Vine Street, Gorton – Planning Ref 128864/OO/2020

Ridge have prepared this technical note to provide a information in relation to Planning Conditions 19 and 20, for Planning Reference 128864/OO/2020.

A response to the points raised in the email of 28th April 2023 and subsequent meeting on 3rd May 2023 are included within this TN.

FIGURE 5.1 CULVERT TRENCH LOCATION PLAN

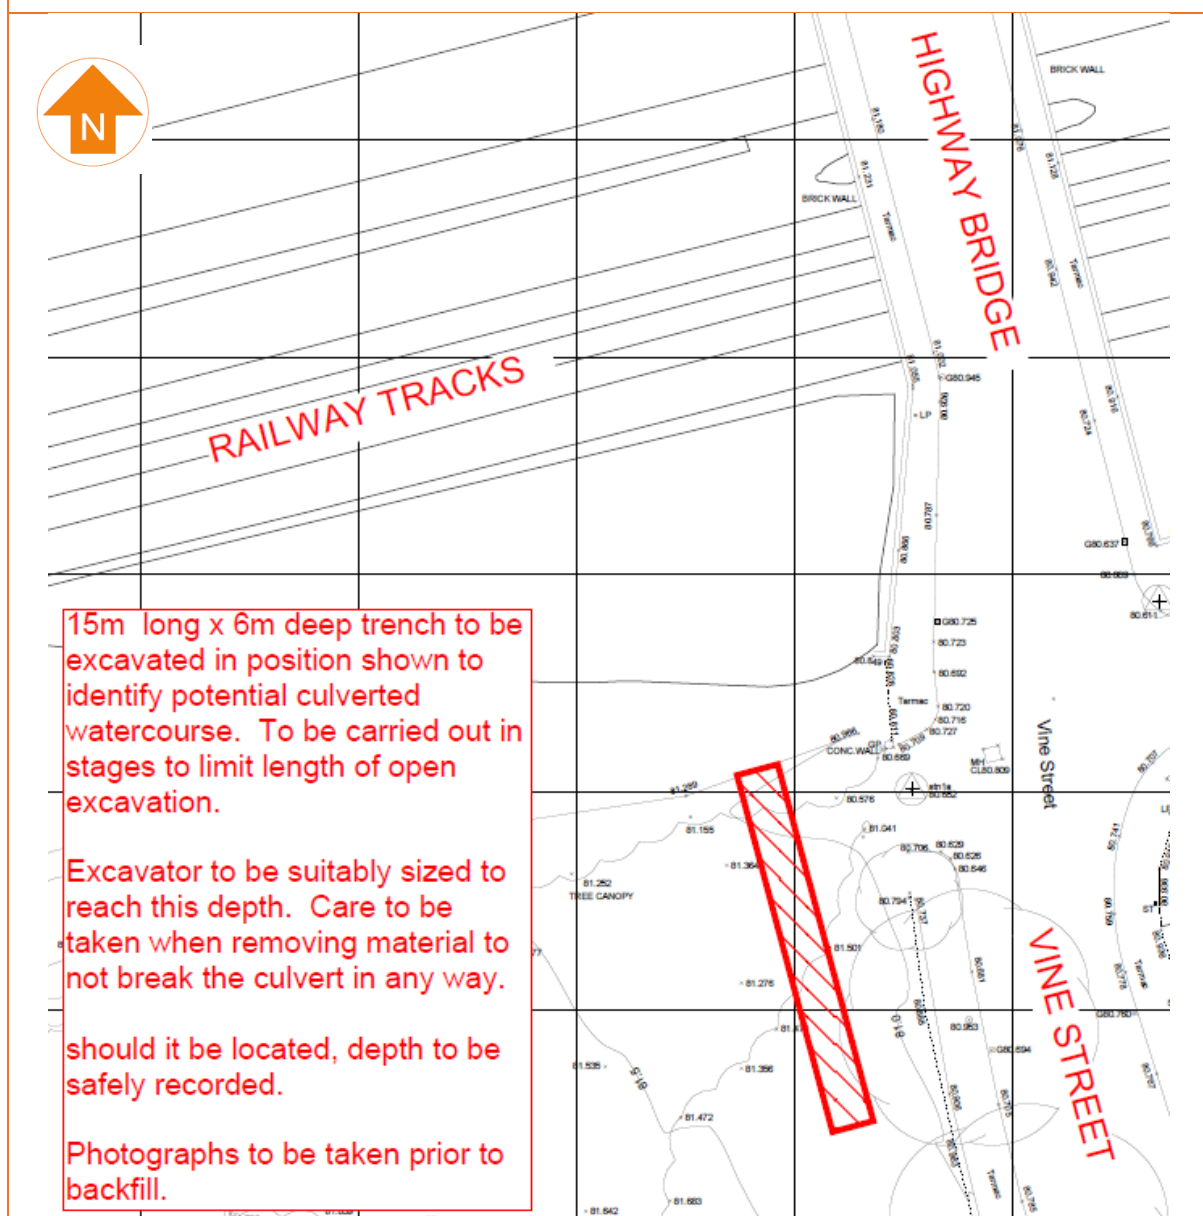
To locate the trench, a 15m long and 6.50m deep slit trench was excavated in a north to south orientation as per the location plan provided by the client (presented in Figure 5.1 below)

No evidence of the culvert was encountered within the trench and photographs of the excavation are presented in Appendix IV.

However, during the enabling works, it is recommended that a watching brief is completed in this area to confirm the presence or absence of the feature.
